**Valentine Gold Project: Federal  
Information Requirements**

Round Three Information Requirements:  
Response to IR(3)-11

**VALENTINE GOLD PROJECT: ROUND THREE FEDERAL INFORMATION REQUIREMENTS**

Appendix IR(3)-11.1 Technical Memo on Updated Groundwater Modelling

**Figure 1 Areas with Water Table Above Ground Surface at Baseline for Original Model in EIS**

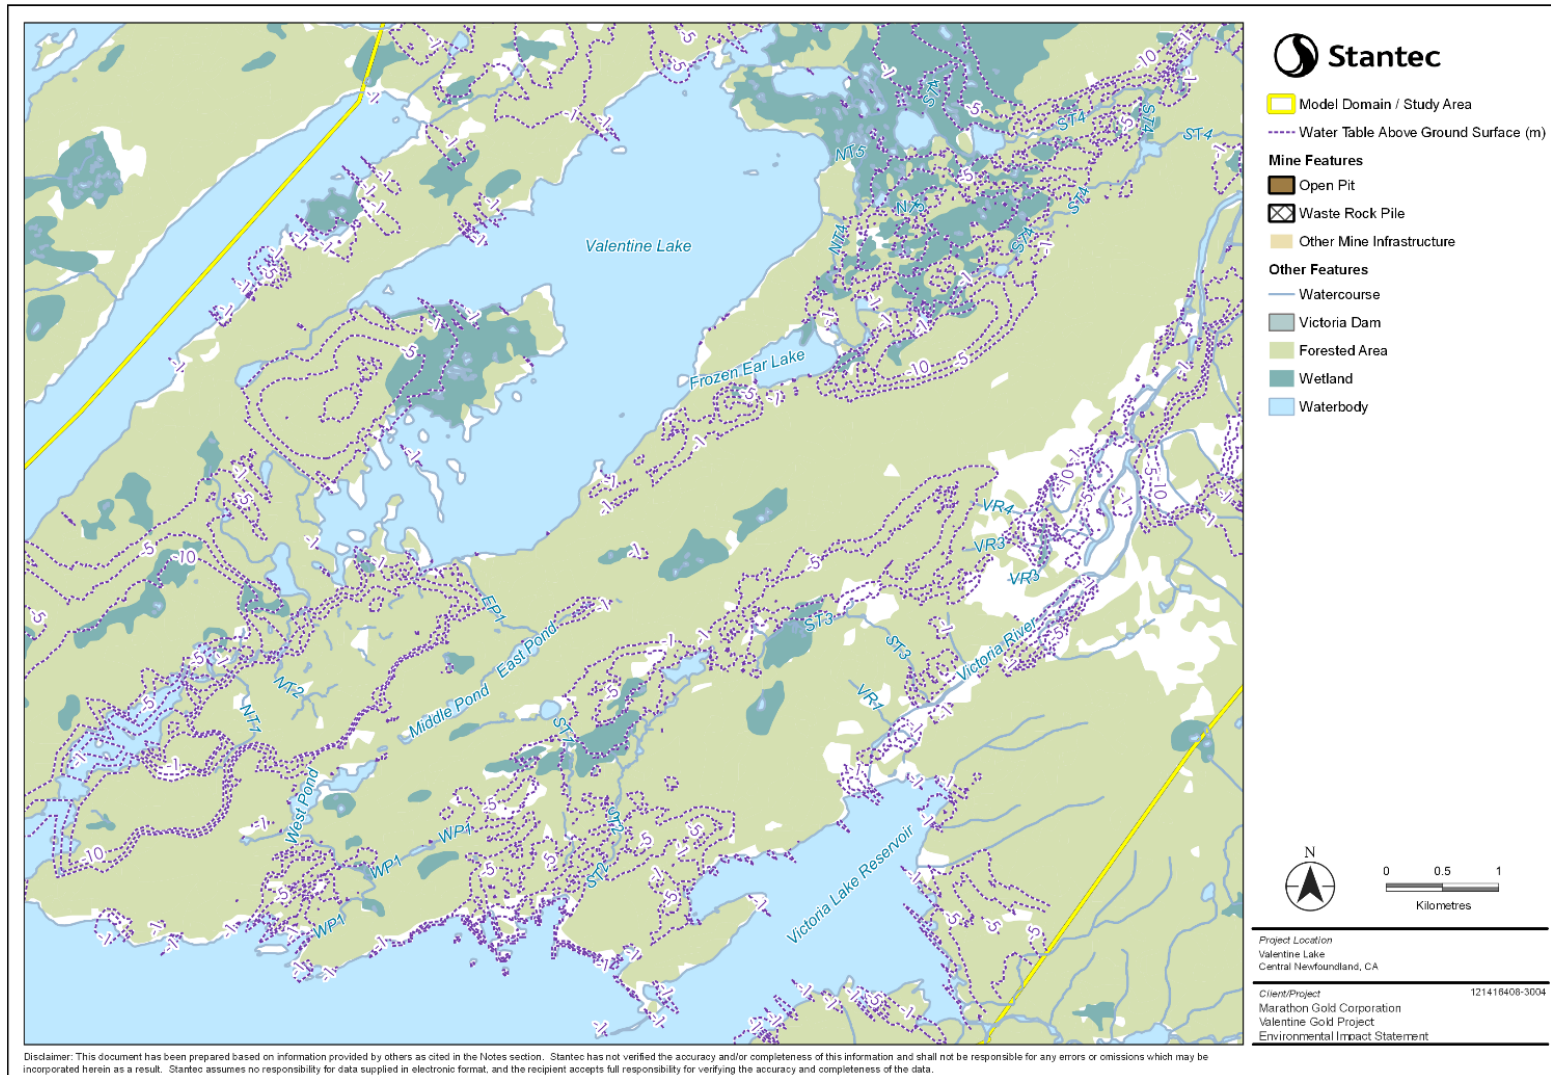
<b>IR 3 Reference #:</b>	<b>IR(3)-11</b>
	<p>Various incongruent model results highlighted in Round 2 (IRs 11, 12, 14, 15) appear to be related to numerical instability, and the related lack of conceptual feasibility from the calibrated model. Some examples include the fluxes at NT3 under baseline conditions and the increase in groundwater flow to NT1 and NT2 at the end of operations relative to baseline.</p> <p>Due to the highlighted concerns regarding the baseline calibrated model, forecast results for groundwater drawdown, and groundwater-surface water interaction cannot be relied upon for the effects assessment.</p>
Information Requirement:	<p>Provide a calibrated baseline groundwater model that aligns with the conceptual model, such that the groundwater table is at, or below the ground surface in the absence of surface water features or significant confining units.</p> <p>Provide forecast model results based on the updated calibrated model that limits numerical artifacts so that the reported results align with the expected outcomes, and applied boundary condition changes.</p> <p>Based on revised model results, update the effects assessment for surface water, fish and fish habitat as applicable.</p>

The numerical groundwater flow model was revised to reduce the simulated groundwater levels where simulated levels were above the ground surface. The areas of the model where simulated water levels were above ground surface occurred in three primary areas, as shown on Figure 1:

Several methods were investigated using the numerical groundwater flow model to address the simulated elevated water levels:

- Incorporating additional evapotranspiration (compared to the net recharge method applied in the groundwater modelling) using the MODFLOW Evapotranspiration package.

- Incorporating potential wetland seepage areas using the MODFLOW Drain package for areas defined using the Saturated Soils layer from the Wooded Areas, Saturated Soils and Landscape in Canada – CanVec Series – Land Features (Natural Resources Canada 2019). This was extended to include low lying areas with ponded water as observed in imagery from Google Earth. The drain stage was assigned based on the ground surface elevation, and the conductance was assigned at 1 m<sup>2</sup>/d. The location of the new drain cells added to the model based on this criterion are provided in Figure 2.

- Reducing recharge by applying a linearly varying recharge multiplier to the net recharge from the EIS model based on surface slope. A recharge multiplier of 0.05 was assigned to slopes greater than 35°, and a recharge multiplier of 1.00 was assigned to slopes of 0°. The calculated surface slope is illustrated on Figure 3, and the function that calculates the recharge multiplier based on ground surface slope is illustrated on Figure 4.

- Increasing the conductance factor for drain features in lowland areas at the base of hill slopes.
